UNITED STATES PATENT AND TRADEMARK OFFICE

APPLICATION NO.	FILING DATE	FIRST NAMED INVENTOR	ATTORNEY DOCKET NO.	CONFIRMATION NO.
10/574,090	03/30/2007	Lino Dreyer	HWR-0183US	8930
21302	7590	03/02/2010	EXAMINER	
KNOBLE, YOSHIDA & DUNLEAVY				
EIGHT PENN CENTER				WRIGHT, MADISON L
SUITE 1350, 1628 JOHN F KENNEDY BLVD			ART UNIT	PAPER NUMBER
PHILADELPHIA, PA 19103			3781	
MAIL DATE	DELIVERY MODE			
03/02/2010	PAPER

Office Action Summary	Application No.	Applicant(s)
	10/574,090	DREYER ET AL.
	Examiner	Art Unit
	Madison L. Wright	3781

DETAILED ACTION

This figure, now referred to as annotated Fig. 1, used for the rejection of claims 1-6 and 8-13 has been replicated below, and the Examiner has added reference points for ease of explanation, and said reference points will be used for the rejection of claims 1-6 and 8-13 below.

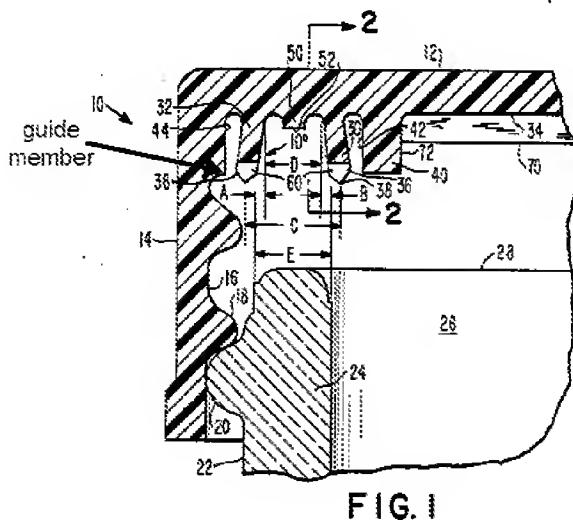
As to claim 1, Dutt teaches a plastics closure (closure cap 10) for a container, the closure comprising a top plate (top 12), a side skirt (side wall 14) depending from the periphery of the top plate (Fig. 1), a sealing strip (outer sealing flange 32) depending from the top plate and adapted to sealingly engage the side of a container neck finish (container neck 24), and an abutment member (outer seal flange abutment surface 44) including a projecting guide member (guide member, annotated Fig. 1) for guiding the sealing strip towards the neck finish as the closure is applied, so that a strength of the seal is increased, wherein the guide member contacts the sealing strip over a relatively small area so that a friction between the sealing strip and the abutment member is minimized; but does not teach wherein the sealing strip is inclined radially towards the neck finish for improving the sealing effect.

Kano teaches a container closure 2 that has a top panel wall 4 where the top panel wall has an annular seal piece 34 that extends downwardly obliquely in a radially inward direction from the inner surface of the top panel wall.

It would have been obvious to one of ordinary skill in the art at the time the invention was made to use the annular seal piece that extends radially inwardly of Kano with the closure as taught by Dutt to reduce the deformation of the top panel (Kano, pg. 2, ¶ 0007).

As to claim 2, Dutt modified by Kano teaches a closure according to claim 1, wherein the sealing strip tapers slightly away from the top plate (col. 4, lines 67-68).

As to claim 3, Dutt modified by Kano teaches a closure according to claim 1, wherein the surface of a free end (free end 36) of the sealing strip tapers sharply (Fig. 1).
